TFT Display Differences

The RM420-015B replaces the RM420-015 at the same price. All orders will be changed automatically. The only difference is the power supply.

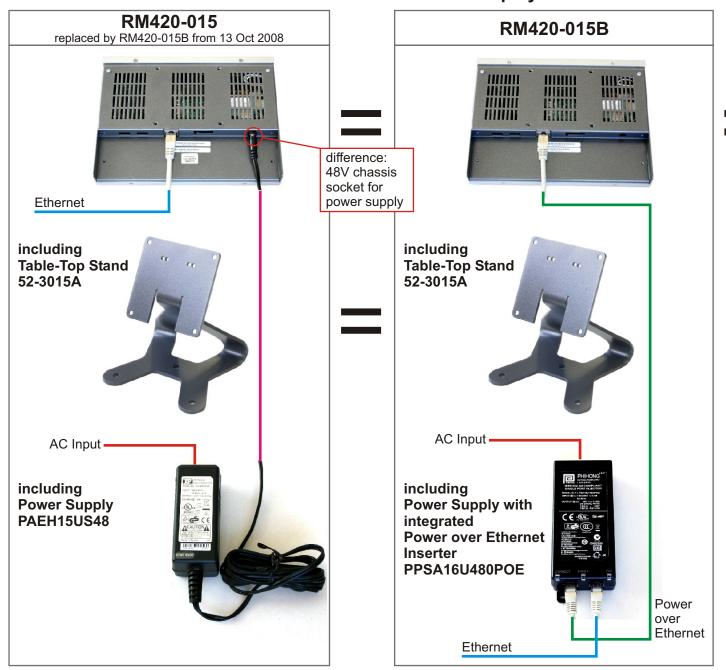
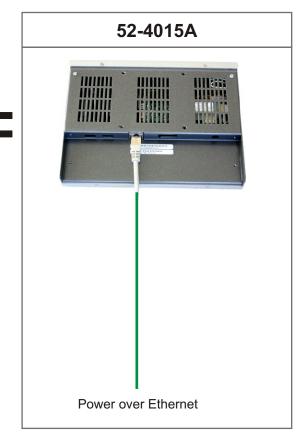
The RM420-015B is supplied by Power over Ethernet using a power supply with integrated Power over Ethernet inserter (PPSA16U480POE). What is different in the display hardware is the now eliminated 48V socket for the 48V power supply.

If you order a 52-4015A, a 52-3015A and a PPSA16U480POE together, you will receive the same hardware set as in item RM420-015B.
